DATE: MARCH 19, 2021

IN REFERENCE TO THE FOLLOWING INSPECTION REPORT

Document Number: 696202458

**Inspected Facilities: SKR MAN CAMP (CHEVRON SHALE W 11-34)**

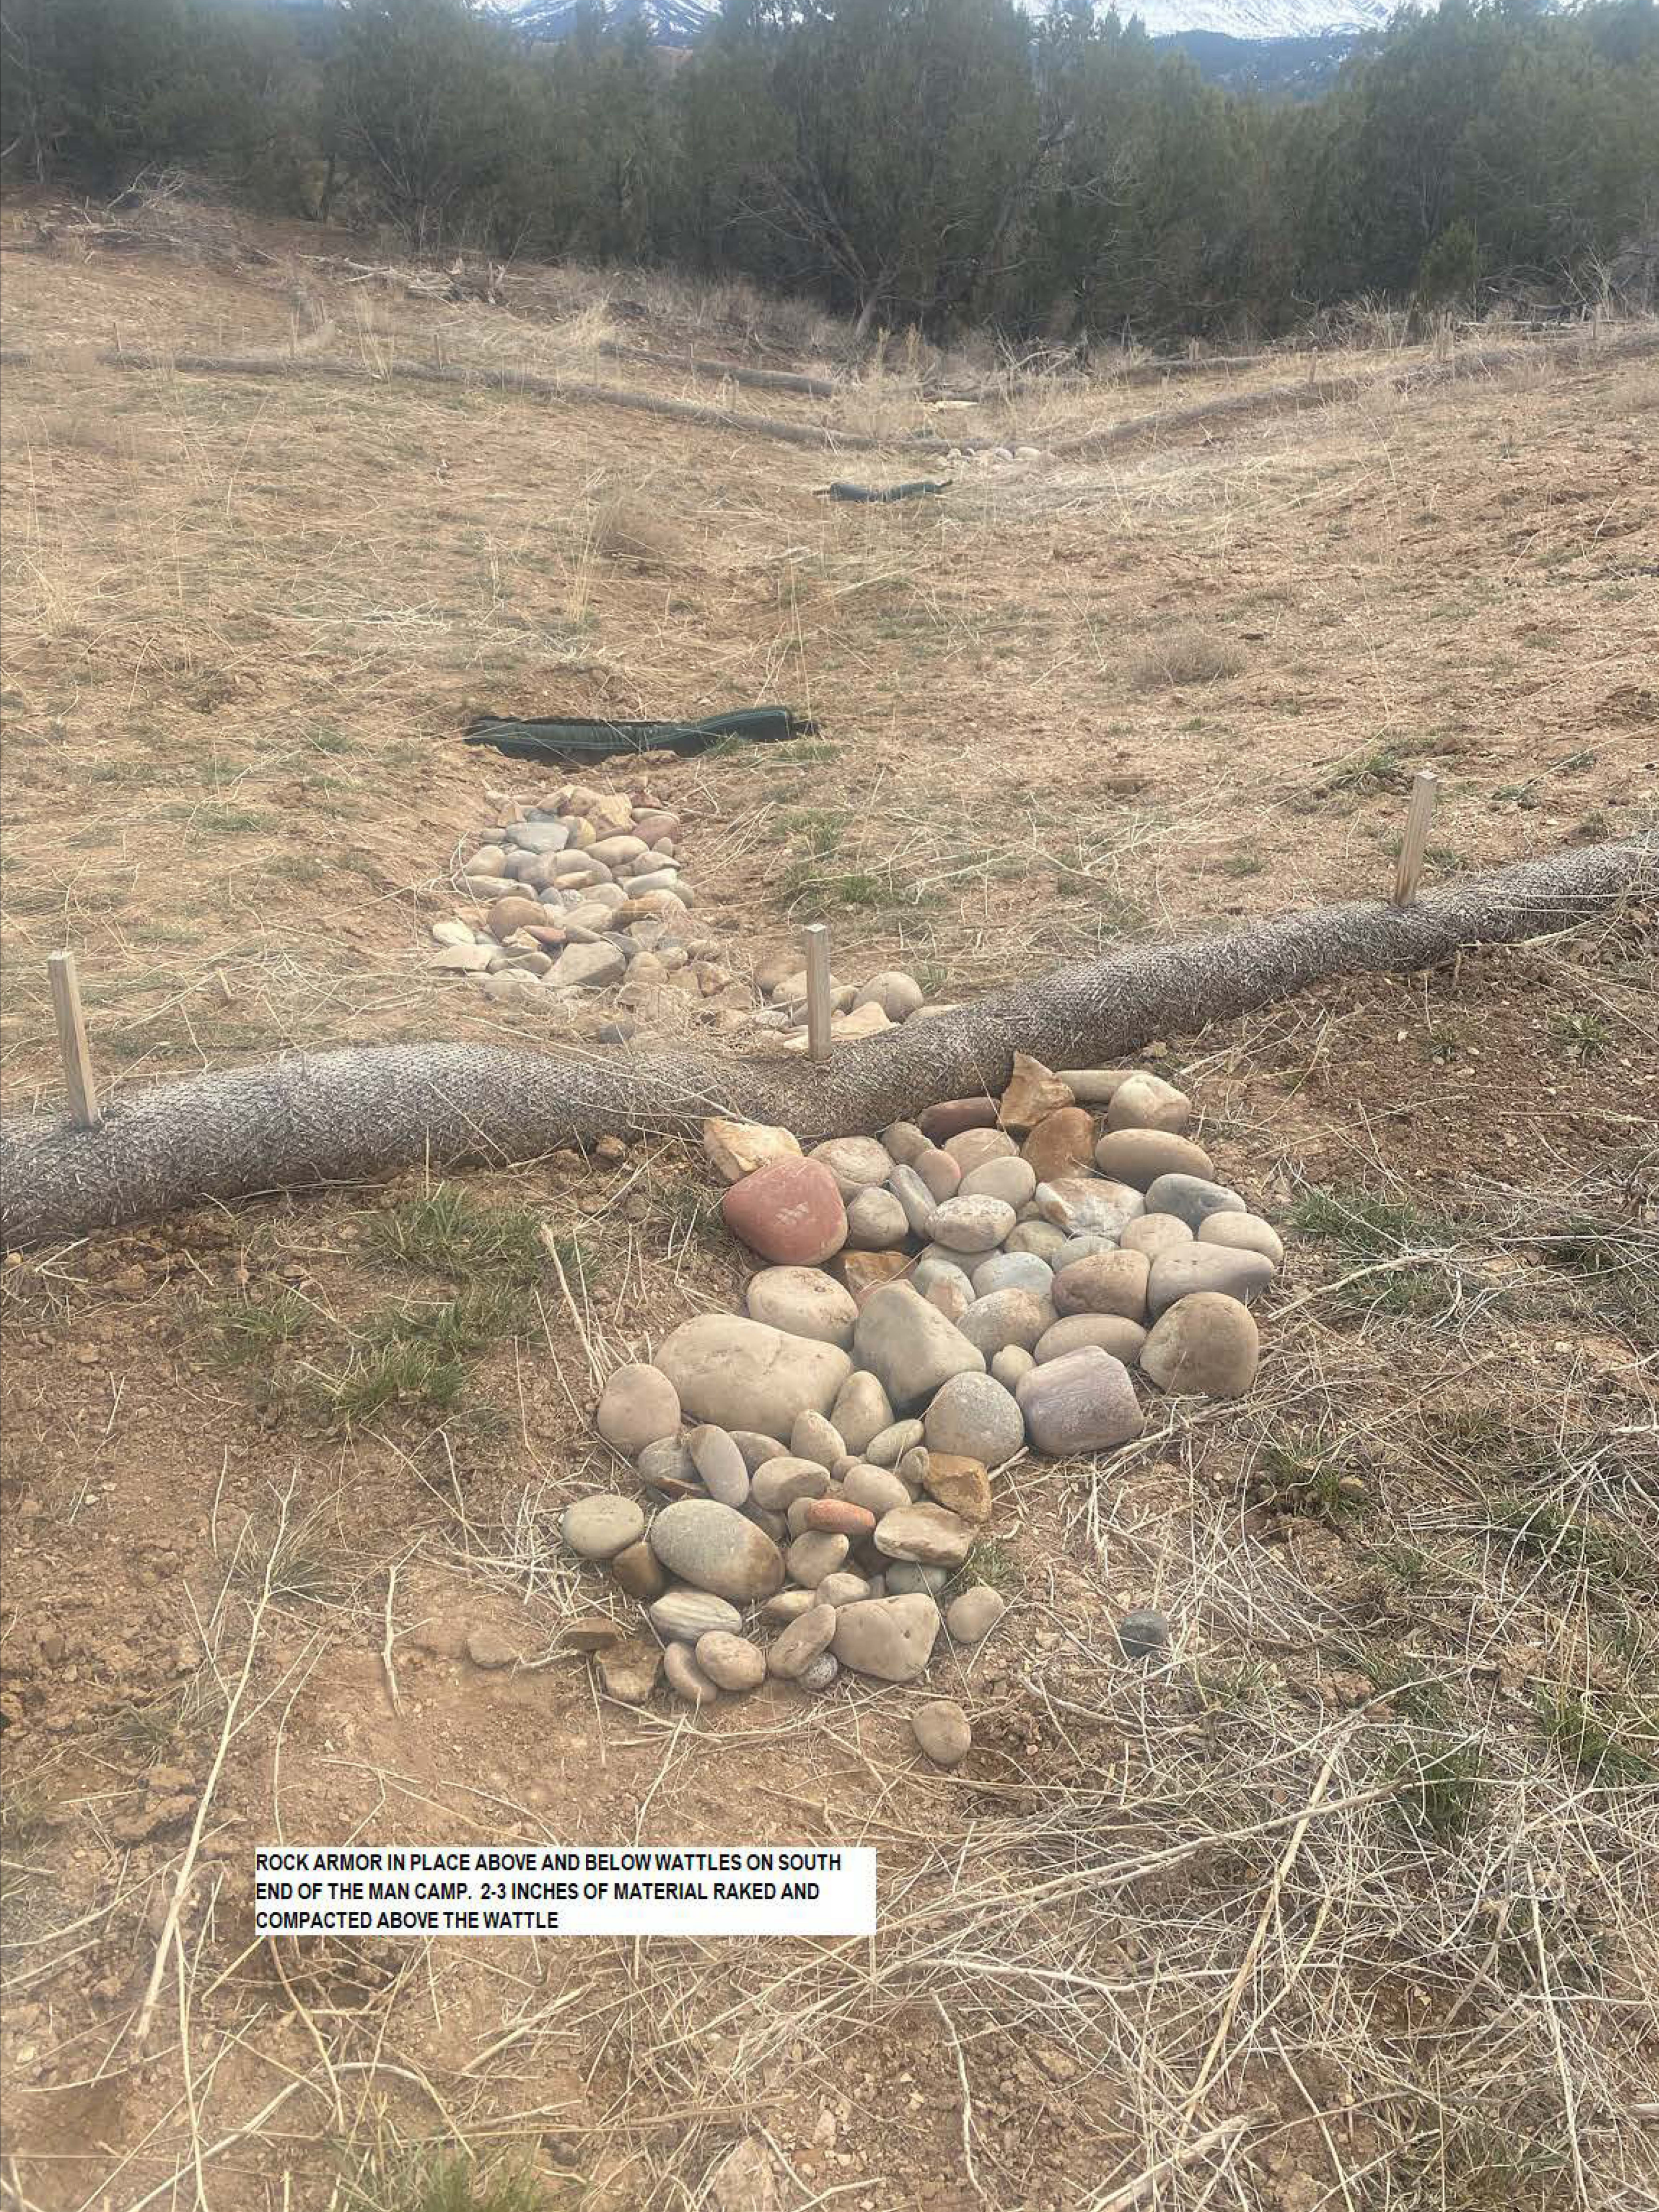
It was observed in this inspection that Operator has installed rock aggregate and rock socks within portions of the erosion channel to be used in conjunction with the wattle control measures, however, the wattle BMPs on the Location remain improperly installed /not installed in accordance with good engineering practices; wattles have not been trenched and backfilled per good engineering practices.

It was observed in this inspection that Operator has installed rock aggregate and rock socks within portions of the erosion channel to be used in conjunction with the wattle control measures, however, the wattle BMPs on the Location remain improperly installed / not installed in accordance with good engineering practices; wattles have not been trenched and backfilled per good engineering practices.

MATERILA RAKED ABOVE WATTLE

2-3 INCH OF WATER RAKEED  
ABOVE WATTLE AND COMPACTED  
RILLING RAKED

2-3 INCH OF MATERIAL RAKED AND  
COMPACTED ABOVE WATTLE.  
RILLING AND EROSION RAKED

ROCK ARMOR IMPLACE TO REDUCE WATER VELOCITY AND REDUCE EROSION.  
ROCK ABOVE AND BELOW WATTIE WITH ROCK IN EROSION TO GONTROL RUN OFF  
WATER,

ROCK ARMOR IN PLACE ABOVE AND BELOW WATTLES ON SOUTH  
END OF THE MAN CAMP. 2-3 INCHES OF MATERIAL RAKED AND  
COMPACTED ABOVE THE WATTLE
